Saturn Textiles Ltd.(Woven)

21 September 2013

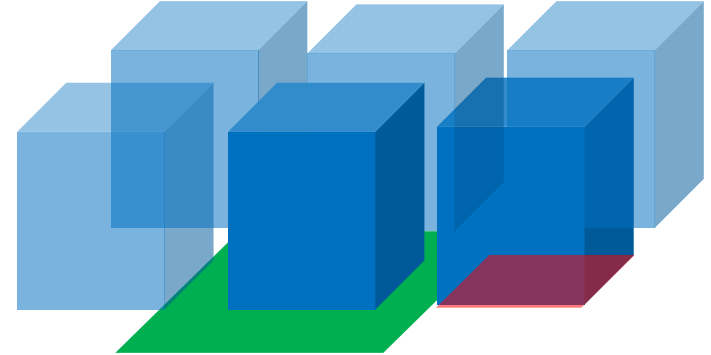
Check on roof structure from localised high loading from water tanks required

Five 5000 litres water tanks mounted on small concrete plinths

Building Engineer to check that beam and slab have been designed to accommodate loads.

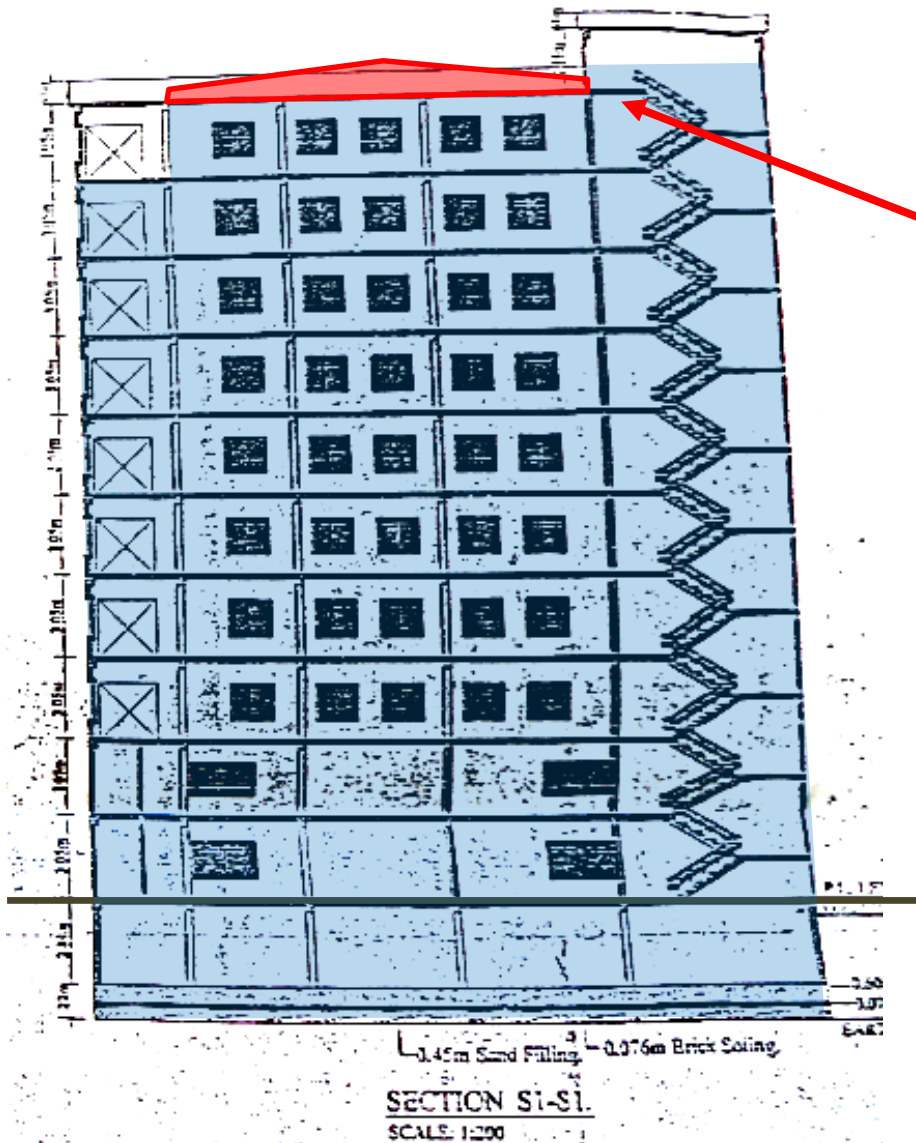
Significant inconsistencies compared to
actual arrangement of the building at
rooftop

Lightweight roof structure doesn't agree with structural drawings for roof top.

Structural drawings show inconsistencies compared to actual arrangement of the building from 1st to 4th floor (edge downstand beams)
